## ADDENDUM #6

DCA Project No.: 22-136  
Project Name: York Region Warehouse Upgrades

**Addendum #:** E01

E-204

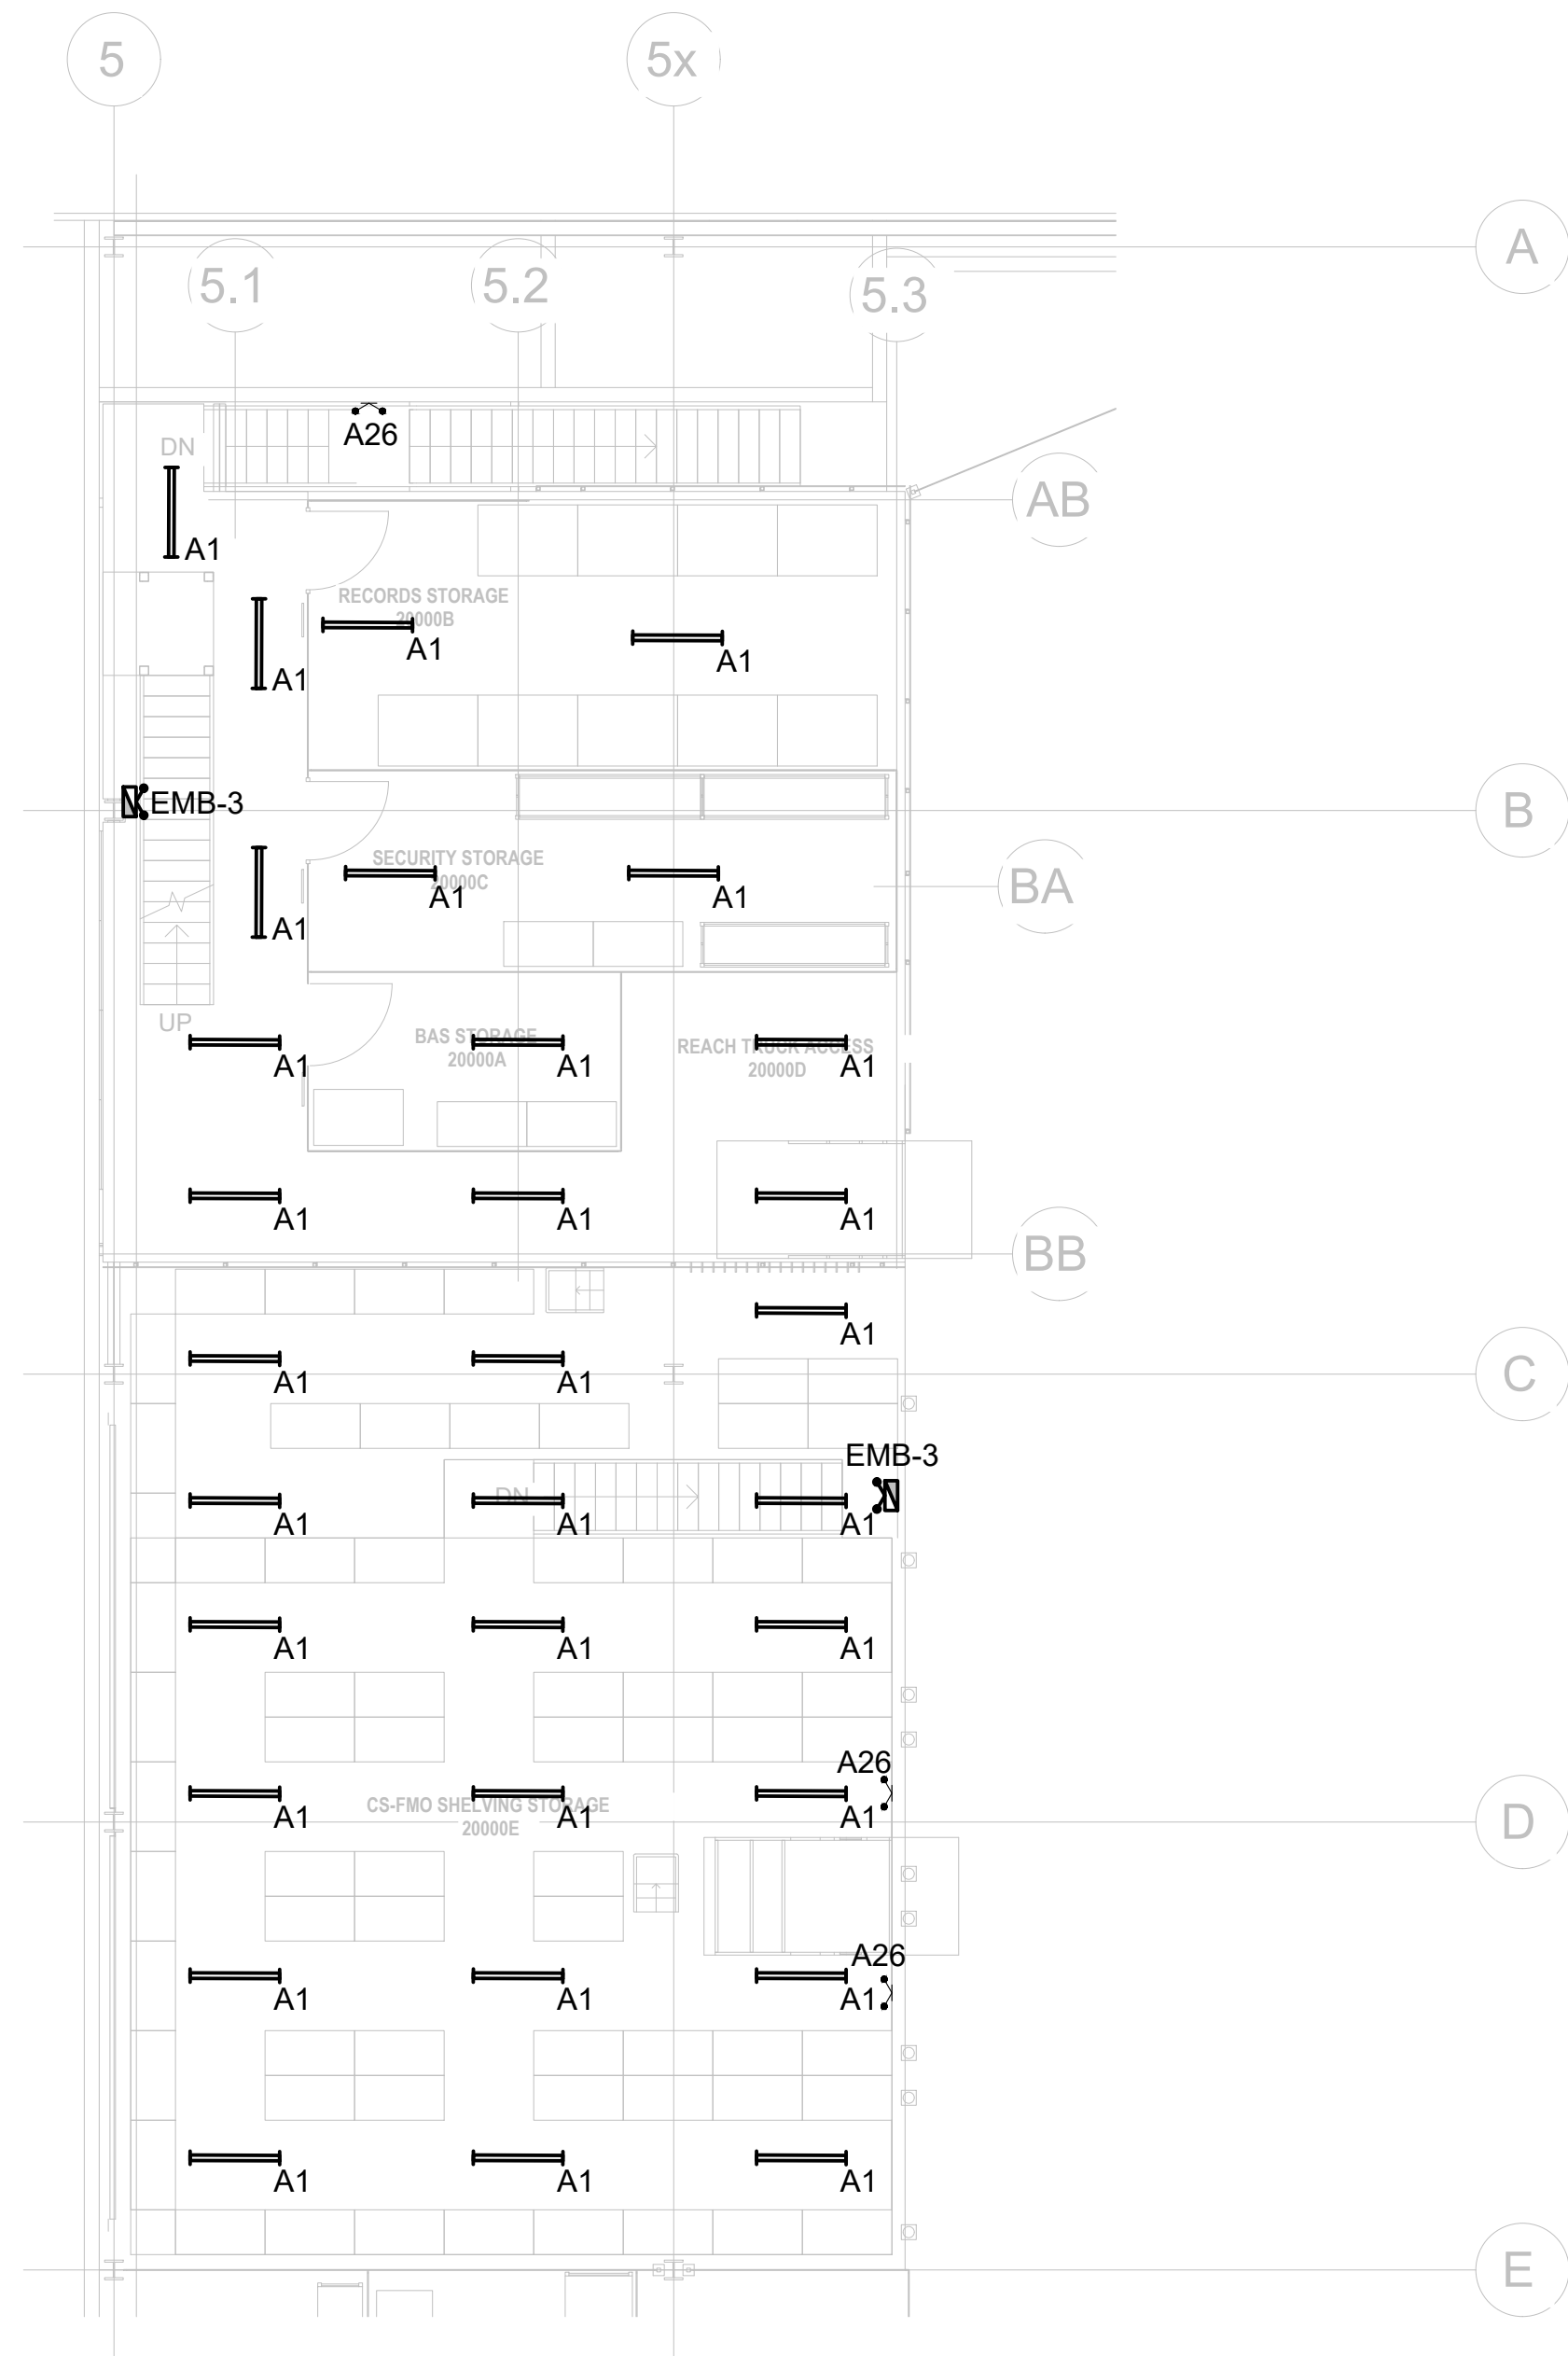
- i) Refer to attached drawing general sheet notes.
- .9 Drawing- E-204- LIGHTING LAYOUT - MEZZANINE LEVEL**
  - i) Refer to attached drawing general sheet notes.

SCALE	AS SHOWN	DRAWING No.	M201
-------	----------	-------------	------

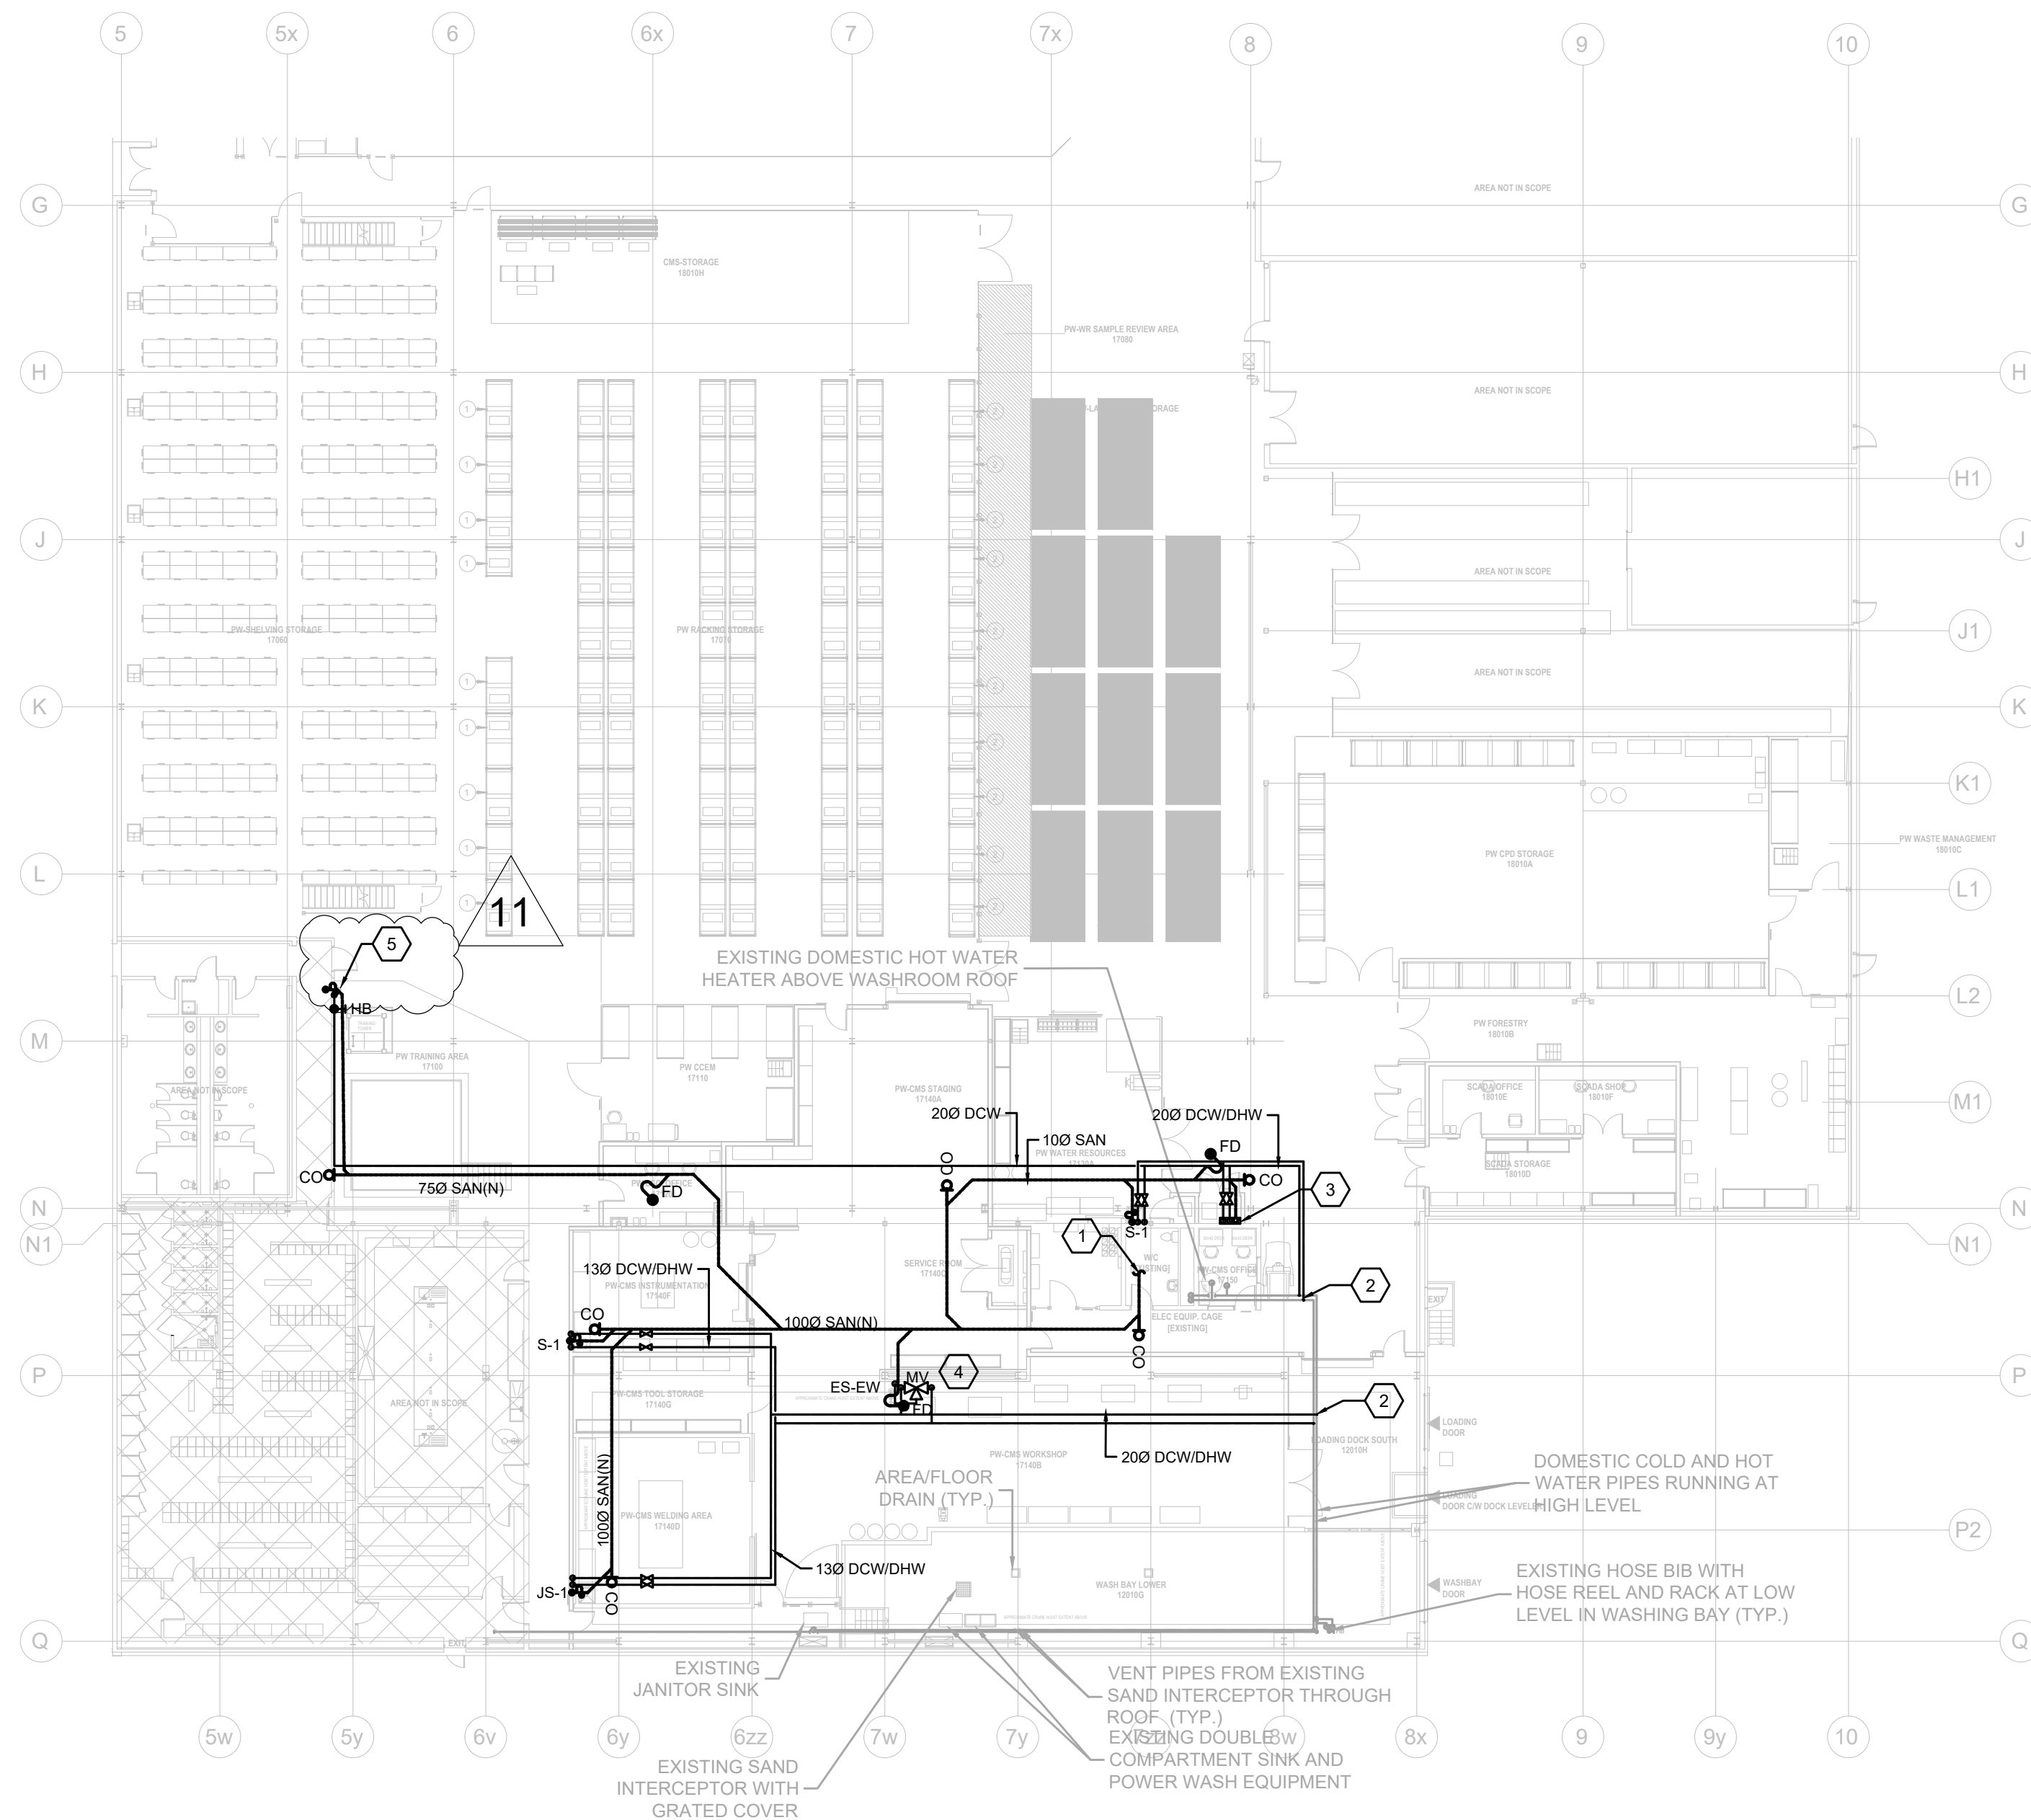
**Changes to Drawings:**
**1. Drawing M201. – Plumbing New Layout**

- a. Additional notation added to clarify new location of the drinking fountain that is being relocated.
  - i. Sheet Keynote 5: Relocated drinking fountain

5. RELOCATED DRINKING FOUNTAIN.
